UNITED STATES  
NUCLEAR REGULATORY COMMISSION  
WASHINGTON, D. C. 20555

The Commission has issued the enclosed Amendments Nos. 100, 100, and 97 for Licenses Nos. DPR-38, DPR-47 and DPR-55 for the Oconee Nuclear Station, Units Nos. 1, 2 and 3. These amendments consist of changes to the Station's common Technical Specifications (TSS) in response to your request dated August 19, 1981.

These amendments revise the TSS to allow the extension of Unit 2 Cycle 5 operation to 390 EFPD.

SAFETY EVALUATION BY THE OFFICE OF NUCLEAR REACTOR REGULATION  
SUPPORTING AMENDMENT NO. 100 TO FACILITY OPERATING LICENSE NO. DPR-38

ROD POSITION LIMITS  
FOR FOUR PUMP OPERATION  
FROM  $150 \pm 10$  TO  $390 \pm 10$   
EFPD - 30  
UNIT 2  
OCONEE NUCLEAR STATION  
Figure 3.5.2-1B2

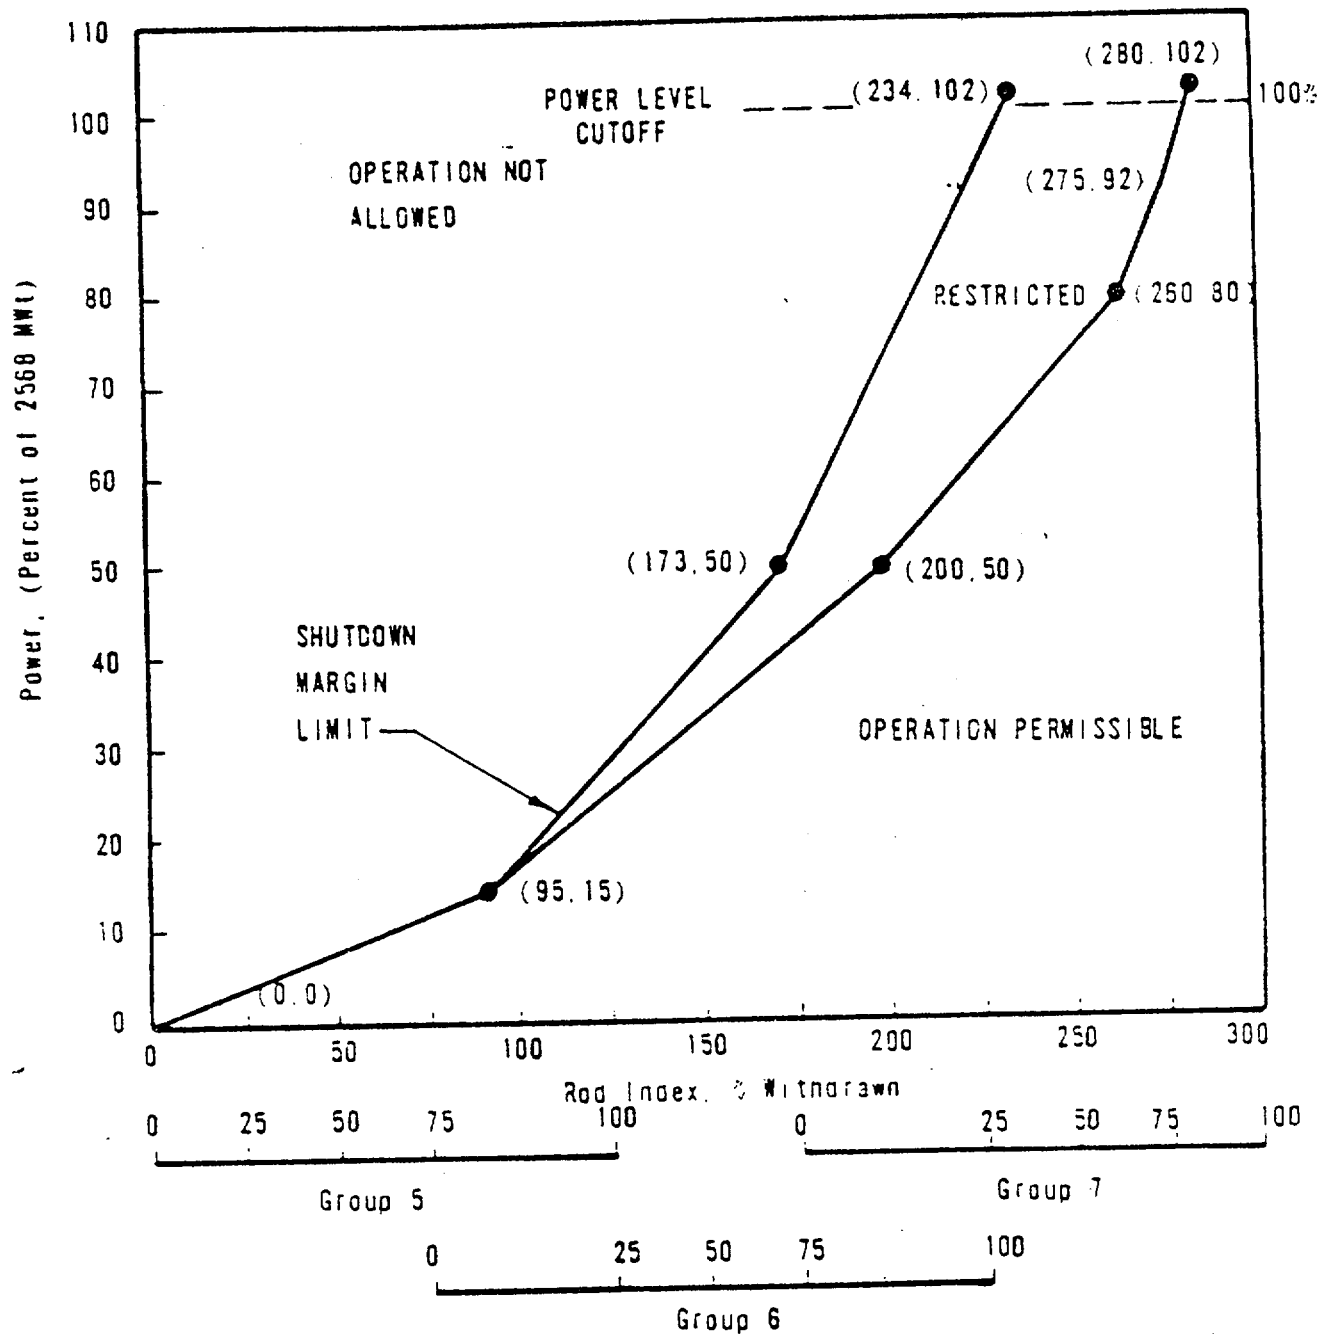
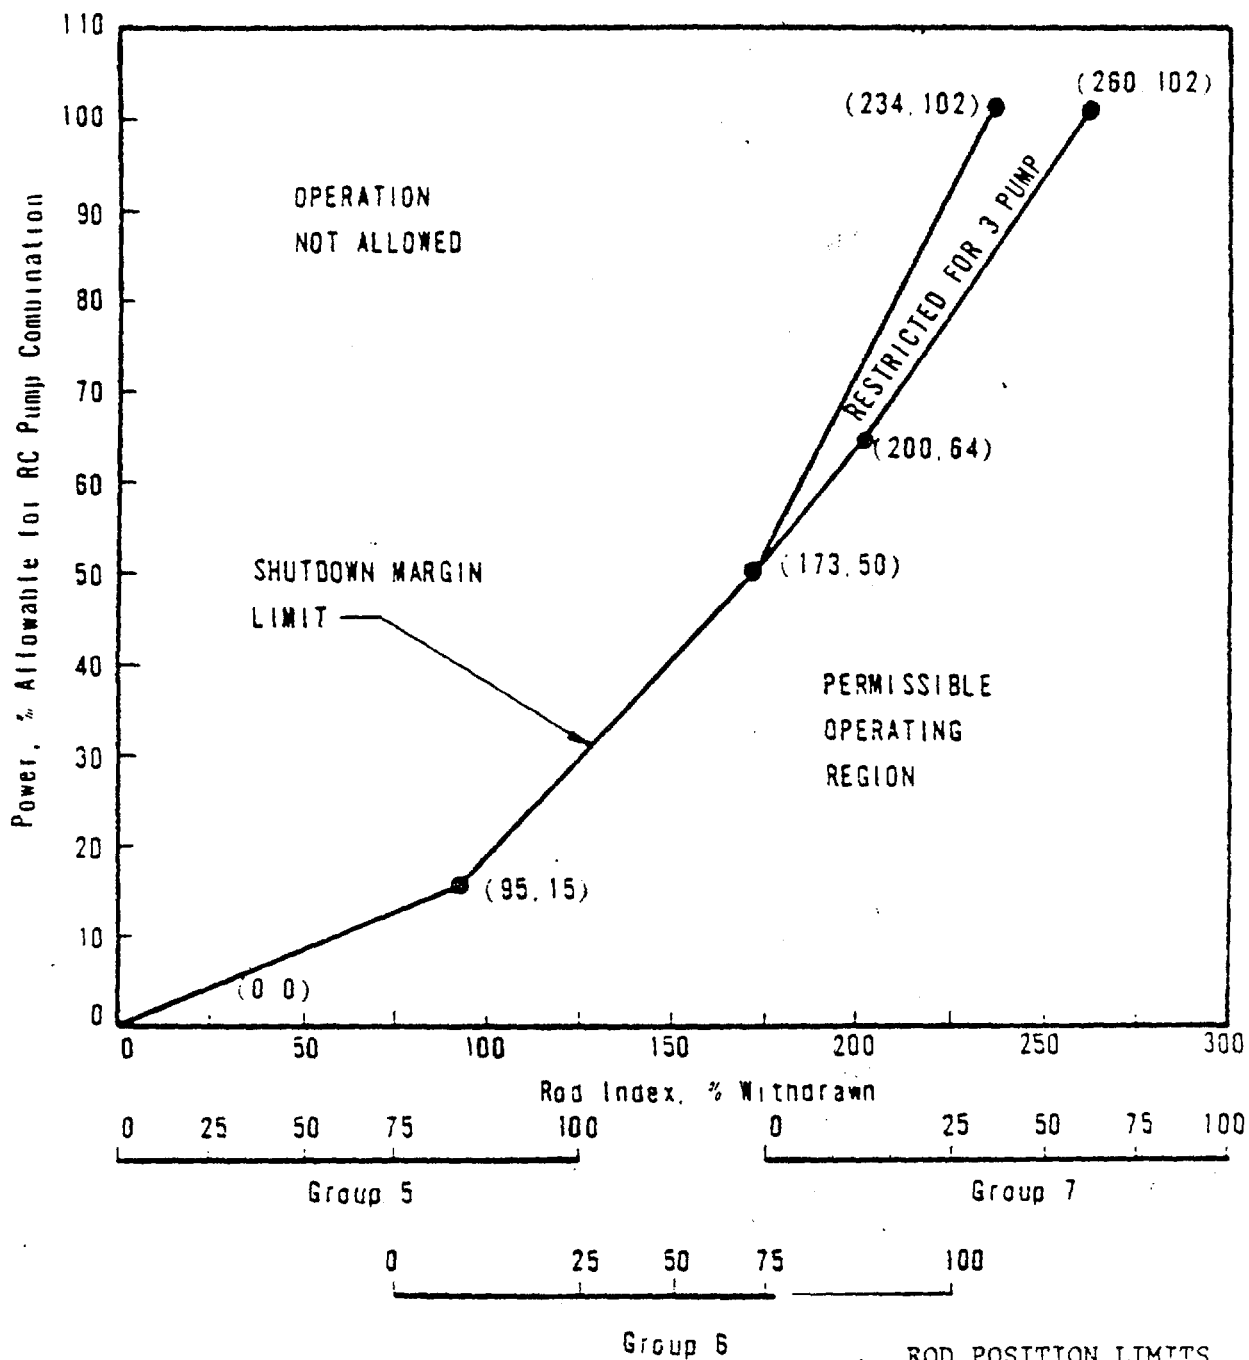
The Commission issued Amendments 83, 83 and 80 for the Oconee Nuclear Station Units 1, 2 and 3 on June 12, 1980, which revised the common TSs related to the full power operation of Unit 2 during Cycle 5. The changes to the TSs with that amendment contained revised figures related to Rod Position Limits for four, three and two reactor coolant pump operation, Power Imbalance Envelop and Axial Power Shaping Rod limits to be effective from  $150 + 10$  to  $360 + 10$  EFPD. By letter dated August 19, 1981, Duke requested that the title blocks for these figures be revised to indicate their acceptability from  $150 + 10$  to  $390 + 10$ , - 30 EFPD to allow for extended operation of Unit 2.

By Amendments 93, 93 and 90, which were issued on February 10, 1981 to support operation of Unit 3 during Cycle 6, a new Specification (3.5.2.9) was included in the common TSs requiring that an evaluation be performed to verify that operational limit curves remain valid for extended operation beyond the nominal design cycle length. In the August 19, 1981 application, Duke informed us that the evaluation required by Specification 3.5.2.9 had been completed and had confirmed that the existing Oconee 2 operating limits remain valid for operation to  $390 + 10$ , - 30 EFPD.
